## TECHNICAL PUBLICATION

### GAFF Torque Rod Bushing Application (Updated)

STEMCO® published Bulletin **575-0152** (September 11, 2019) refers to the GAFF® Torque Rod Bushing Part Number 11729 – outlines the New Design (Gen 3) and applications (Torque Rod Bushing).

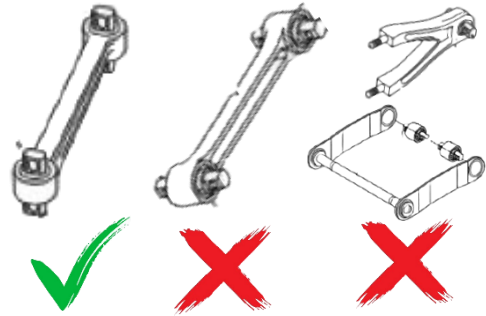
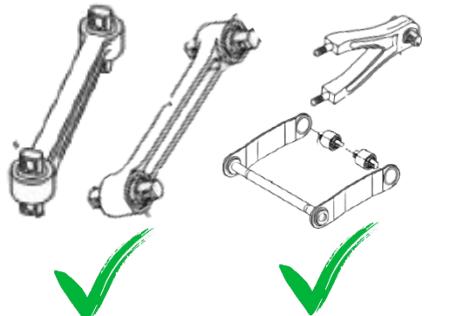
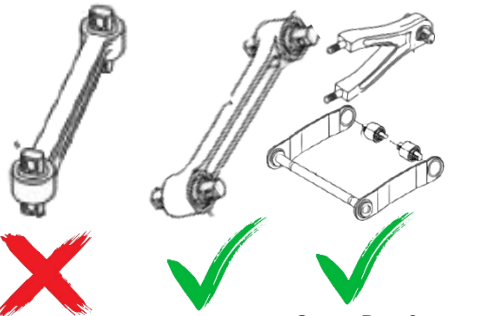
In summary – whilst 11729, 13520 & 83520 have identical Outside Dimensions & Centre to Centre Measurements, **NOTE: Key design characteristics of each unit are different.**

<p align="center"><b>11729</b></p> <p align="center">Torque Rod Bushing Upgraded Bush with Stress Release Design</p> <p><b>Application:</b> Suit Kenworth® AirGlide 200/400/460/690 &amp; NeWay® ADZ 123/126/246/252/369/378 (Vertical Mount Torque Rod Bushing)</p> <p><b>NOTE:</b> Not to be fitted in Sway Bar Application or Horizontal Mounted Torque Rods.</p>	<p align="center"><b>13520</b></p> <p align="center">Torque Rod &amp; Sway Bar Bushing O.E. Design</p> <p><b>Application:</b> Suit Kenworth® AirGlide, NeWay® AD/ADZ, Hendrickson®, DTNA FAS Airliner (Freightliner®, Sterling® &amp; Western Star®) Suspensions.</p> <p><b>NOTE:</b> Suit both Torque Rod &amp; Sway Bar Applications.</p>	<p align="center"><b>83520</b></p> <p align="center">Torque Rod (Horizontal Mounted) &amp; Sway Bar Bushing Easy Mount, High Articulation Design</p> <p><b>Application:</b> Suit Kenworth® AirGlide, NeWay® AD/ADZ, Hendrickson®, DTNA FAS Airliner (Freightliner®, Sterling® &amp; Western Star®) Suspensions.</p> <p><b>NOTE:</b> Suit Horizontal Torque Rod &amp; Sway Bar Applications.</p>

<p>Vertical Mounted Torque Rod ✓</p> <p>Horizontal Mounted Torque Rod ✗</p> <p>Sway Bar &amp; Sway Bar Arm ✗</p>	 <p>Vertical &amp; Horizontal Mounted Torque Rod ✓</p> <p>Sway Bar &amp; Sway Bar Arm ✓</p>	 <p>Vertical Mounted Torque Rod ✗</p> <p>Horizontal Mounted Torque Rod ✓</p> <p>Sway Bar &amp; Sway Bar Arm ✓</p>
<p align="center">DIRECT O.E.</p> <p>NeWay® 900-08-265, 90008265</p>	<p align="center">DIRECT O.E.</p> <p>DTNA IPC227720, IPC936420</p> <p>Hendrickson® 44695, 44695-000, 64400-002, 66649-002, 66649-003</p> <p>Kenworth® 227720, 836940, 839310</p> <p>NeWay® 900-08-265, 90008265</p>	<p align="center">DIRECT O.E.</p> <p>DTNA IPC227720, IPC936420</p> <p>Hendrickson® 44695, 44695-000, 64400-002, 66649-002, 66649-003</p> <p>Kenworth® 227720, 836940, 839310</p> <p>NeWay® 900-08-265, 90008265</p>
